TRANS/WP.29/GRPE/2001/8
20 March 2001

World Forum for Harmonization of Vehicle Regulations (WP.29)

PROPOSAL FOR DRAFT SUPPLEMENT 2
TO THE 01 SERIES OF AMENDMENTS TO REGULATION No. 67

Transmitted by the Expert from the European LPG Association (AEGPL)

Figure 4: Light vehicle Euro-connector configuration

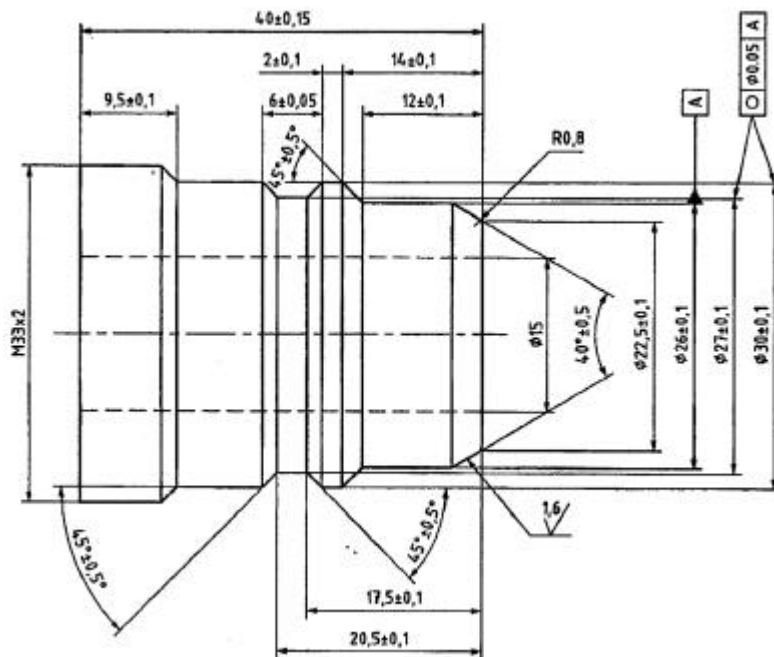
- 6.15.14.6. Specific provisions for the light vehicle Euro-connector:
- (a) The dead volume between the front sealing surface and the front of the non-return valve shall not exceed 0.1 cm³;

- (b) The flow through the connector at a pressure difference of 30 kPa shall be at least 60 litres/min, if tested with water.

Figure 5: Installation of the light vehicle Euro-connector

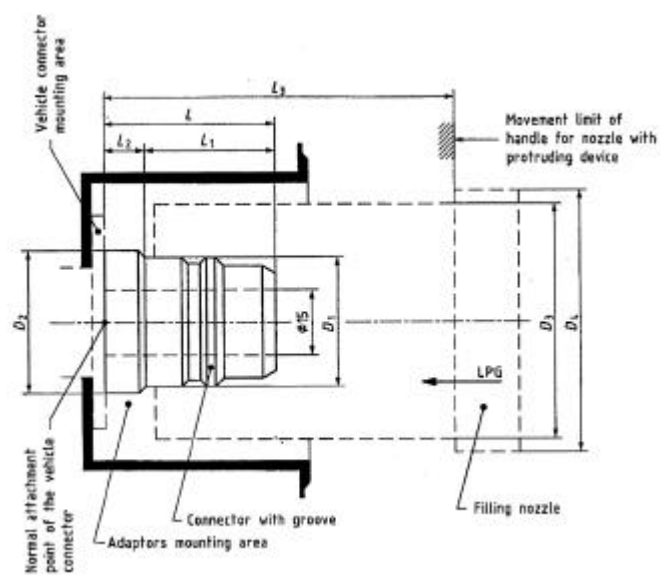
- 6.15.14.5.2. It shall be impossible to remove the connector body from the valve body without specific measures or the use of dedicated tools.
- 6.15.14.5.3. The split between the 2 bodies shall be at the normal fixing point as indicated in annex 9, figure 5.

- 6.15.14.5.4. The length of the connector body of any type, not taking the length of the male thread in account, shall not exceed L in annex 9, figure 5.

Figure 6: Critical dimensions of the heavy duty vehicle Euro-connector

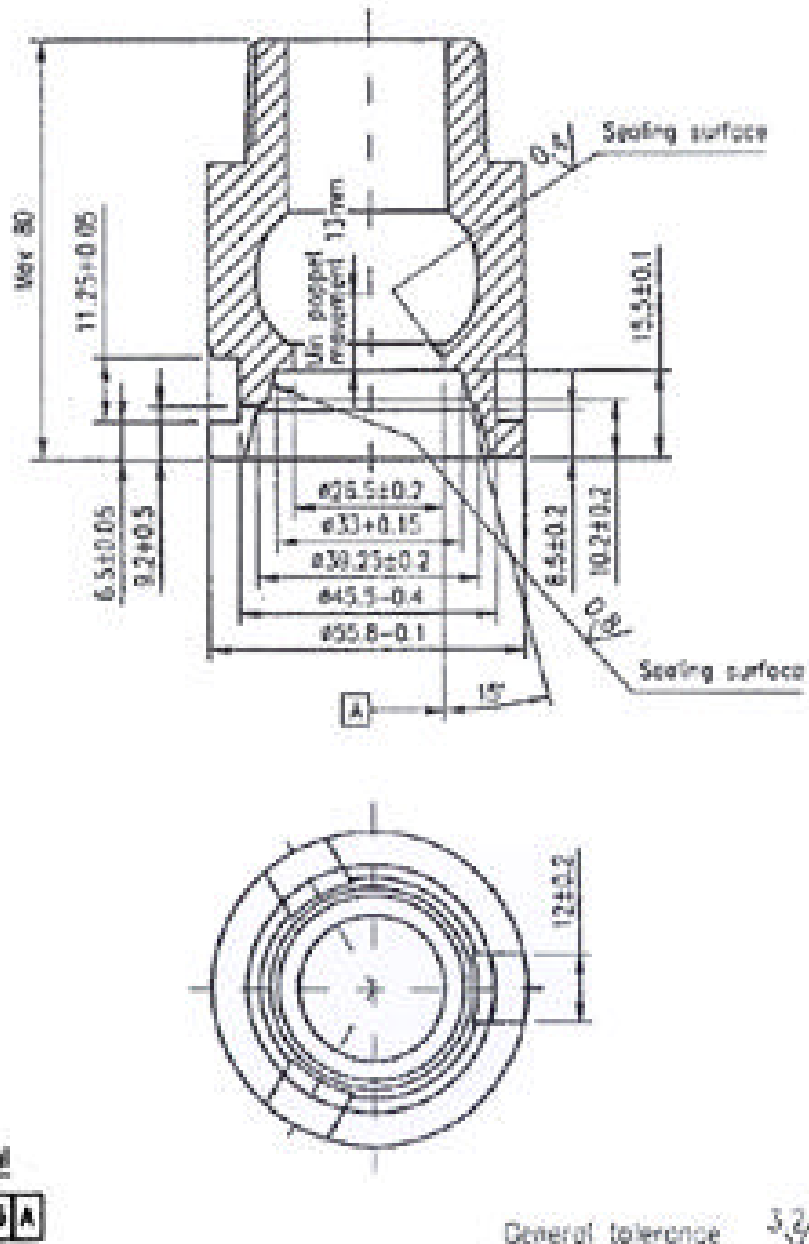
- 6.15.14.7. Specific requirements for the heavy-duty vehicle Euro-connector:
- (a) The dead volume between the front sealing surface and the front of the non-return valve shall not exceed 0.5 cm³;
 - (b) The flow through the connector, with the non-return valve mechanically opened, at a pressure difference of 50 kPa shall be at least 200 litres/min, when tested with water.
- 6.15.14.8. The design and dimensions of the vehicle connector must comply with those in the figures in annex 9.
- 6.15.14.8.1. Examples and critical dimensions of current vehicle connector attachment points and sealing area configurations are shown in annex 9, paragraph 9.
- 6.15.14.8.2. Examples and critical dimensions of the light vehicle and heavy-duty vehicle Euro-connectors are given in annex 9, paragraph 10."
